# SERVICE INFORMATION LETTER

**Subject:** Shaft External Spline Slightly Oversize Possibly Affecting Installation

Service Information Letter No: 130123-001  
 Page 1 of 4

**Figure 1, Inner Shaft Showing Oversize Spline Area**

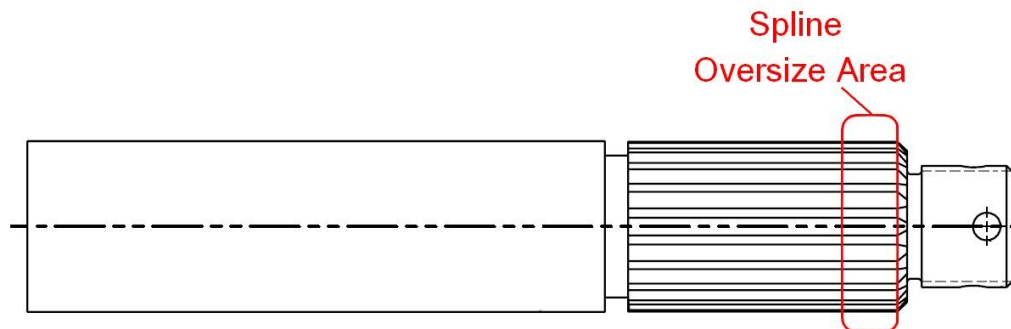
An unknown quantity of the Wencor Inner Shaft's PN 65B13152-3WE were manufactured with a slightly oversize external spline (approx. .0004") as measured on the pitch diameter over pins. The oversize condition was found to be near the end of the spline area as shown in Figure 1. This condition may affect or prevent the installation of the Shaft into the NHA if the internal spline on the mating part is at its minimum size creating a tight fit condition.

The manufacturing process of the Shaft did not account for the possibility of spline taper, which appears to be the cause for the out of tolerance condition. When the Shaft spline was inspected, the end of the spline area was not measured, but only the middle area was measured which was found to be within tolerance. The end of the spline area, which was slightly out of tolerance was not properly inspected, which allowed the out of tolerance Shafts to be accepted, sold to customers and put into service.

Wencor has taken appropriate corrective action to ensure all Inner Shafts manufactured after August 2012 meet the size and process requirements as defined on the Wencor drawing.

**Figure 2, Inner Shaft in Passenger Door Handle Mechanism**

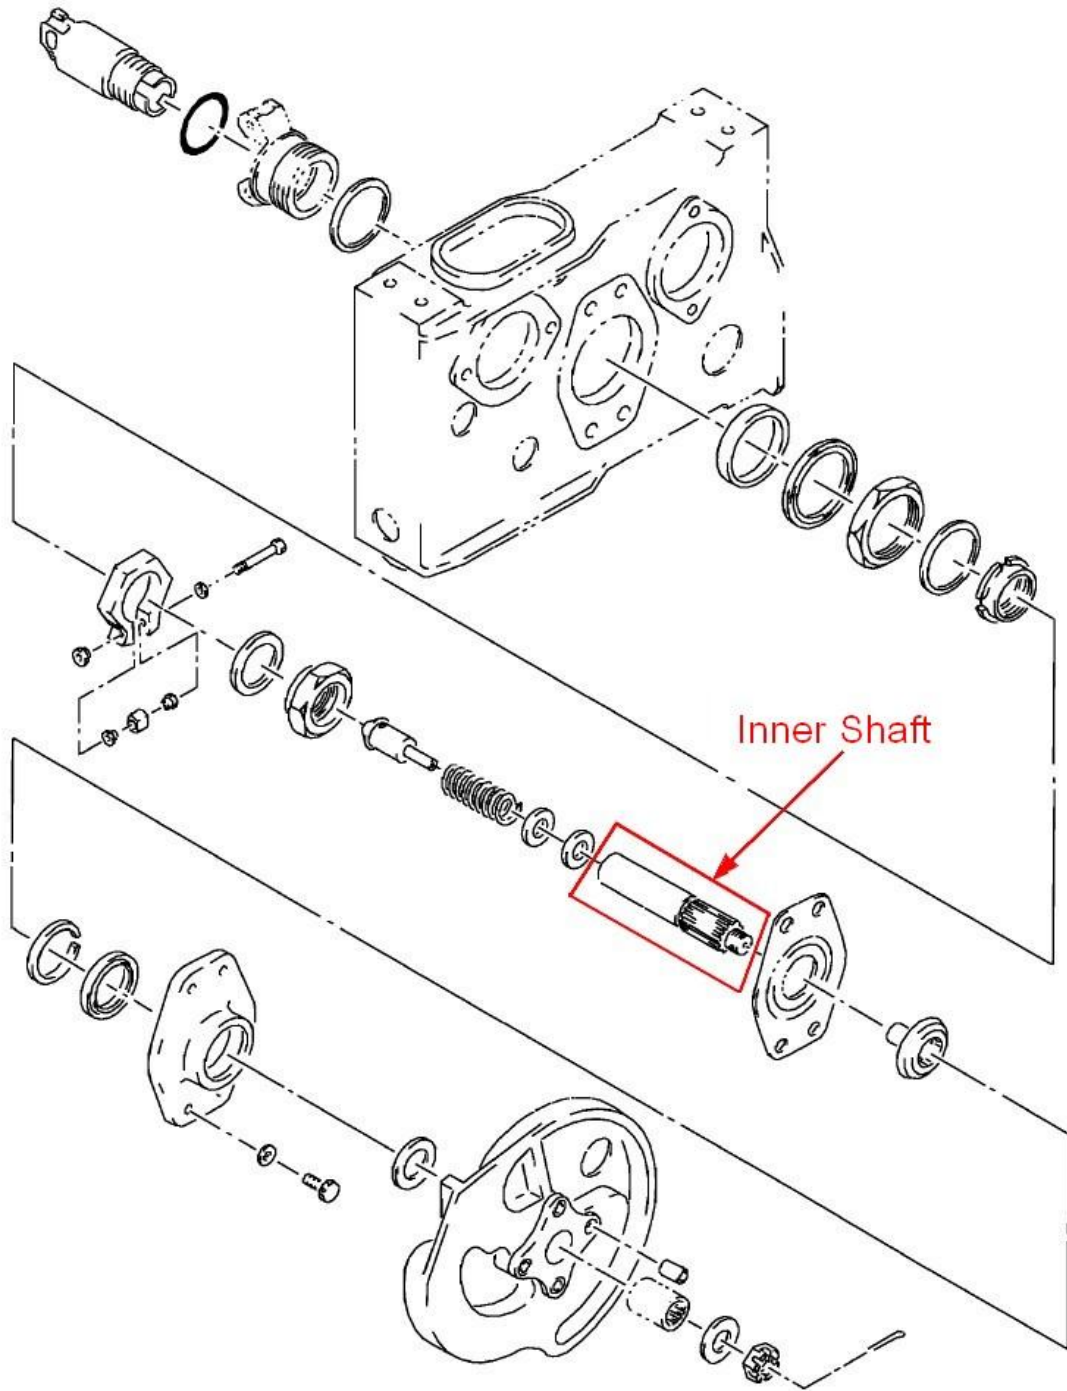
To confirm acceptable usage of the Wencor Inner Shaft, the user shall perform a fit check with the NHA. If the Wencor Inner Shaft can be installed in a normal manner according to the CMM (see Figure 2), the Wencor Inner Shaft can be put into service without any concerns.

If the user suspects an out of tolerance condition on the spline or has trouble installing the Wencor Inner Shaft into the NHA, the Shaft should be returned to Wencor for replacement.
